## Product Change Notice

LED die change for TH Lamps and SMT Lamps

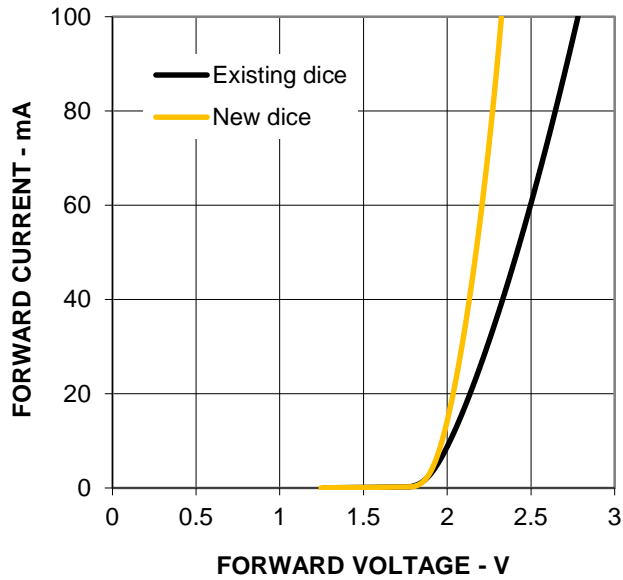
Introduce new LED die as current LED die supplier has ceased operation. The new replacement die is an existing qualified die for Broadcom

There is no change in product's fit, form, function, quality or reliability. There will be change only in the I<sub>F</sub> vs V<sub>F</sub> graphs as shown below.
